Subject: LOTCIP Scope Change/Funding Increase Request – Coventry Swamp Road Project

Coventry Swamp Road Alignment/Intersection Improvement Project (L032-0003)

Alternative A

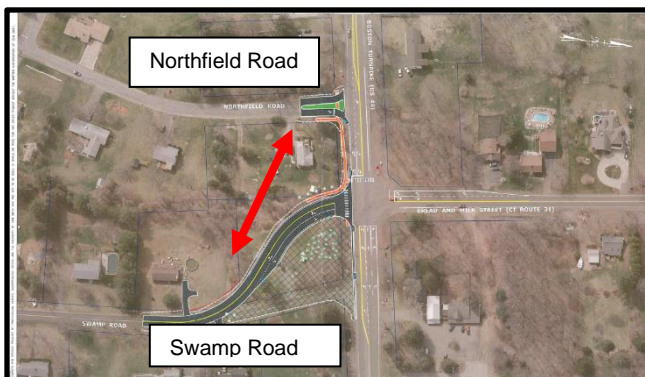
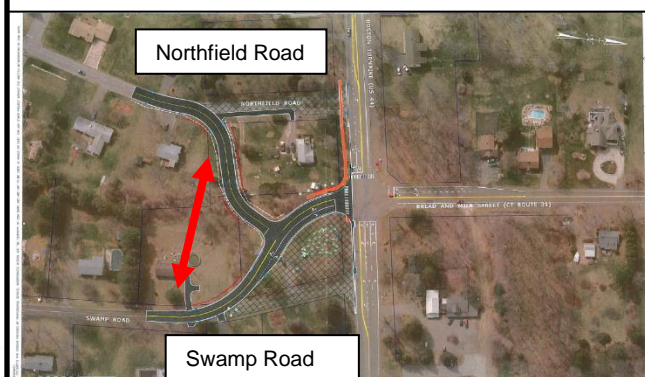
The cost increase and scope modification request is to address feedback necessitated by a project review meeting with CTDOT Local Roads, Traffic and District 1 Units. The original design, depicted in Alternative A, retained Northfields Intersection with Route 44, but restricted access with Right In/Right Out. Along with the public access, this Northfield Road connection provides a required second emergency access to a residential area. The District, however, felt strongly the elimination of the local access point on State Route 44 was necessary.

Therefore, a modified design was agreed upon, depicted in Alternative B, that realigned Northfield Road to provide access via a new intersection with the realigned Swamp Road. The new design's additional construction cost is estimated at \$211,000.

Additional parcel acquisitions will also be necessary with additional right-of-way (ROW) costs estimated at \$56,000.

Additionally, with the realignment of Swamp Road to the existing CT State Routes 44/131 signalized intersection, the CTDOT Traffic Unit is requiring installation of a new signal, mast arms, etc. at a cost of \$500,000 (instead of the originally assumed signal configuration).

To incorporate CTDOT feedback, staff recommends committee approval of a scope change modification realignment of Northfield, adding new signalization and ROW costs, at an additional \$753,800 of LOTCIP funding for the Coventry (L032-0003) project, increasing the funding approval from \$1,419,600 to \$2,173,400.
